NEW MEXICO OIL CONSERVATION DIVISION
 - Geological & Engineering Bureau -
 1220 South St. Francis Drive, Santa Fe, NM 87505

Applicant: CHEVRON USA INC **OGRID Number:** 4323
Well Name: DIGNITAS 26 STATE SWD 1 **API:** 30-015-44202
Pool: SWD; SILURIAN-ORDOVICIAN **Pool Code:** 98191

APPLICATION FOR AUTHORIZATION TO INJECT

RE: Dignitas 26 State SWD No. 1; API 30-015-44202; Admin Appl pMAM1818051178; 1920' FSL / 200' FEL; UL I, Sec 26, T25S, R27E, NMPM

WELLBORE SCHEMATIC

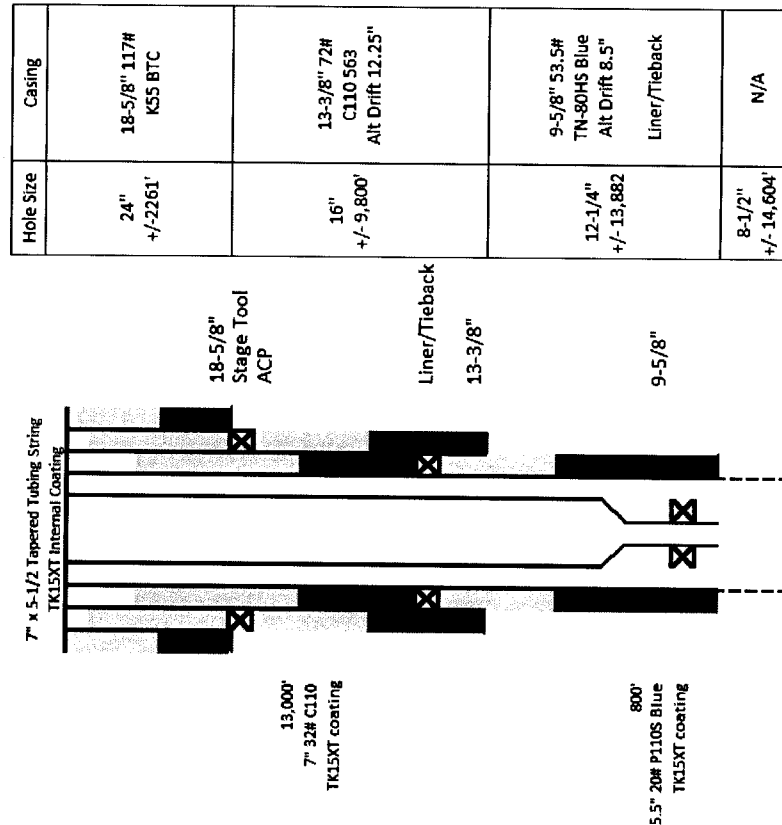
In drafting the final order for this well, I find no design for the tapered tubing set – the 7-inch to 5.5-inch tubing. In the conversation with the technical team on the requirements for the well not to go to hearing, a depth for the taper conversion was suggested. I would like someone at Chevron to recommend a depth based on the model used for the IS assessment submitted for this well.

I also notice that the stage tool for the 9 5/8-inch liner tie back is above the shoe of the 13 3/8-inch intermediate casing. How would Chevron address the issue of the 9 5/8-inch liner tie with the 13 3/8-inch casing should the cement fail to reach past the 13 3/8-inch shoe? Better to know now. PRG

We apologize for the delayed response, but would like to provide clarification regarding your questions around the cementing operations for the 9-5/8" liner tie-back:

1. During drilling of the 12-1/4" section of the nearby Gravitas SWD we experienced high gas which could have resulted in a potential well control situation. One of the concerns was having a well control event while running casing due to the length of the string and requiring the BOPE to close on the casing. By running a liner, we can close on the drill pipe which is easier and quicker to execute.
2. Additionally, it was determined that during the cementing operation of a long string the hydrostatic pressure of the cement could be greater than the breakdown pressure of the formation. This would lead to losses during the cement job and potentially poor zonal isolation. The packer of the liner will also ensure cement will circulate above the liner top and the zone below will be isolated.

1. Due to the fact that we are running a liner with a tie-back a DV tool is not needed. The item depicted on the 9-5/8" string, in the picture, represents the liner hanger and packer.
2. The reason for the liner hanger and packer to be located above the shoe is because it is not good practice to set the liner hanger and packer inside of the previous casing string shoe track. This is to help us avoid any potential issues with sealing the packer inside the 13-3/8" due to potential cement sheath left behind.

1. By cementing the liner first, the hydrostatic pressure in the annulus will be less than breakdown pressure of the formation (as opposed to long string cement job). This will minimize losses and help ensure cement is above the 13-3/8" shoe.
2. Our procedure is to pump enough excess cement volume such that the cement will be above the liner hanger packer.
